SERVICE BULLETIN

Document n°	CUC-SB2006-01-New microswitch on cooker door-GB
Brand	Smeg
Models envolved	Freestanding cookers 90x60,90X60PB, 60x60,60x50,80X50PB, 80x50T
Cause	Improvement of microswitch efficiency
Description of modification	The door receiver+microswitch assy have been replaced by an independent microswitch fixed directly on the oven front frame and by a door receiver. For this reason the frontal part of the oven has been modified, adding a hole for the microswitch (see details)
Date of introduction	From 07/10/05 onwards
Interchangeability	NO -- The new microswitch cannot be mounted on the appliances produced before this date, as there is no hole in the front part of the oven to fix it.

OLD CONFIGURATION

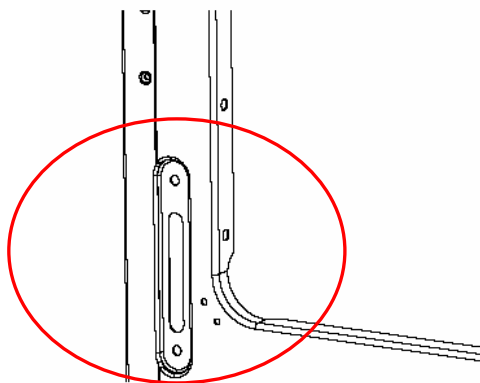
MICROSWITCH
PARTNO
814490491

DOOR RECEIVER ASSY PART N° 695970056

DETAILS OF SWITCH FIXED TO DOOR RECEIVER

NEW CONFIGURATION

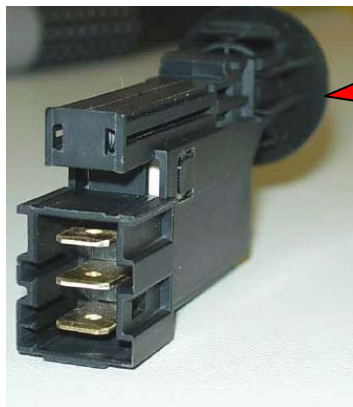
The door receiver+microswitch assy and the oven front part have been replaced with: a new microswitch, the related support for the fixing, a new oven front part and an independent receiver has been added replacing the old door receiver+ microswitch assy.

DETAIL OF MICROSWITCH
SUPPORT PART NO.762371692

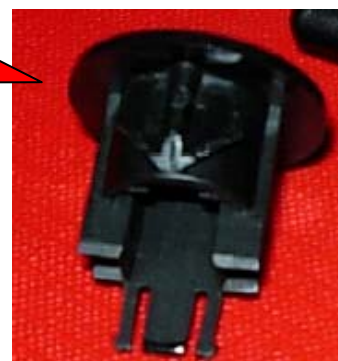
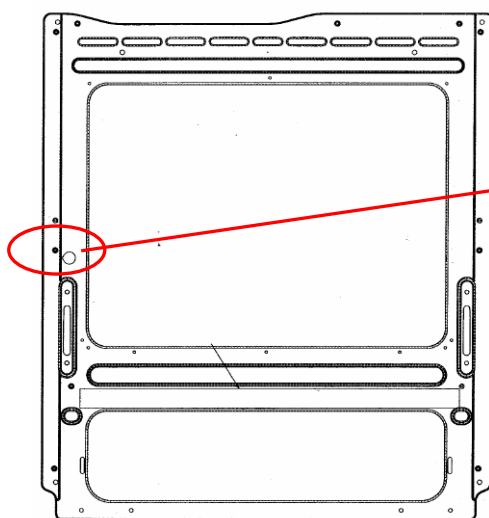
DETAIL ON MICROSWITCH FIXING
